# Defroster Fan Fuse Upgrade

# BULLETIN

**MODELS AFFECTED: 2011 MODEL YEAR BBCV "VISION" EQUIPPED WITH FEATURE 30026-06 OR 30026-07 6" AUXILIARY FAN WITH METAL GUARD.**

**Access Door**

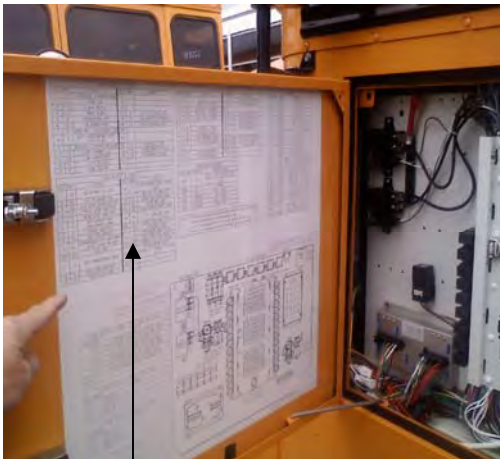
2. Unlatch and open exterior access door located below driver side window. (See above photo)
